Technical Analysis of the Potential for Interference from DARS Terrestrial Repeaters to WCS and MMDS/ITFS Services.

George W. Harter, Director of Broadband Wireless Engineering for MSI

ATTACHMENT D

Engineering Statement of George W. Harter

Figure 1 – Spectral separation between DARS Repeaters and WCS

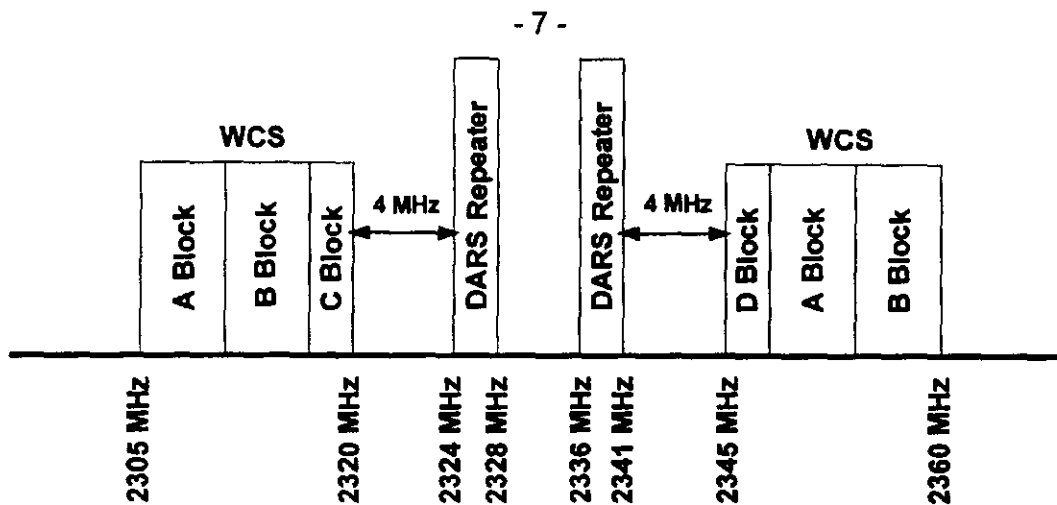
The proposed terrestrial DARS repeater frequencies are separated from the WCS C and D block frequencies by only 4 MHz on each side as shown in the following figure. In order for WCS receivers to prevent potential overload conditions with a DARS repeater operating at a 40 Kwatt EIRP in close proximity, a filter with at least 50 dB of attenuation at DARS frequencies would be necessary. A filter with this level of attenuation is impractical to use because of the cost and size.

Figure 2 - Potential interference from initial DARS repeater deployment to WCS receivers

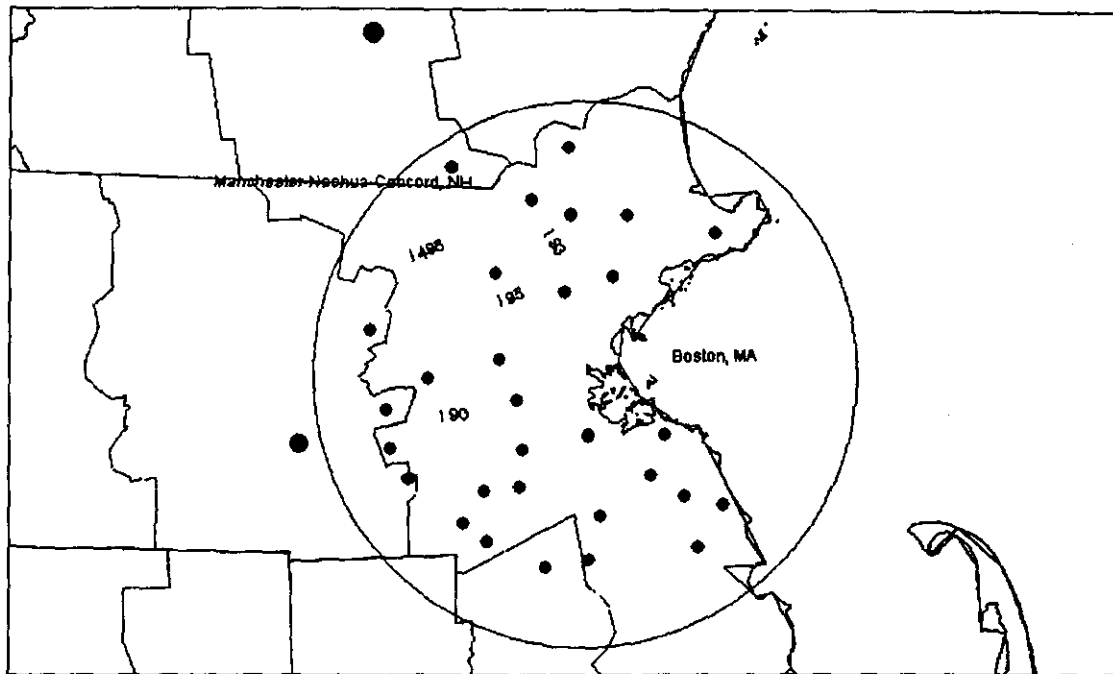
Absent a limitation on the EIRP of DARS repeaters, the area surrounding each DARS repeater of potential interference to WCS receivers becomes extremely large. For example, the existing receiver used by Metricom has an overload point of -25 dBm at the input to the receiver. This is the level at which an interfering signal will cause unacceptable degradation to the BER of the WCS signal. The typical installation utilizes a small, economical receive antenna with a gain of 7dBi and a very broad beamwidth. Every Metricom WCS receiver located within 4,705 feet of a 12 KWatt DARS repeater would be vulnerable to interference. For a 40 KWatt DARS repeater, a Metricom WCS receiver would have to be 8,563 feet, or 1.6 miles, away to avoid interference. The following map shows the potential areas of interference for the proposed initial deployment of high-power DARS repeaters in the Boston area. The areas of potential interference are indicative of the power levels proposed by the DARS operator.

Of course, this map does not illustrate the potential interference from the XM lower-power repeaters or from Sirius' repeaters, as the number and location of these devices is unknown. Nor is any additional margin added into the equation for propagation anomalies. Moreover, the above areas of interference are representative for only one model of WCS receiver (Metricom), one which happens to have exceptional overload performance. Typical receivers will have input overload points between -25 and -35 dBm and will utilize various antenna gains. Under some common deployment scenarios, the interference areas shown above are expected to triple in size.

In order for the potential interference problem to be manageable, the area of interference should be 100 feet or less around each DARS repeater location. However, in order to control the potential for overload to within 100 feet of a 40 KWatt DARS repeater location, a filter with at least 50 dB of attenuation would have to be utilized. A quotation was obtained from a filter manufacturer for a filter that would provide at least 32 dB of attenuation at the worst case response point in the DARS repeater band. This filter would cost approximately \$400 per receiver (in volume) and would be so large physically (2.5"H x 10"W x 6"L) as to make installations like the existing Metricom implementation impractical. Obviously, obtaining more attenuation than this was deemed even more impractical. Moreover, even if we assume use of the impractical and costly filter
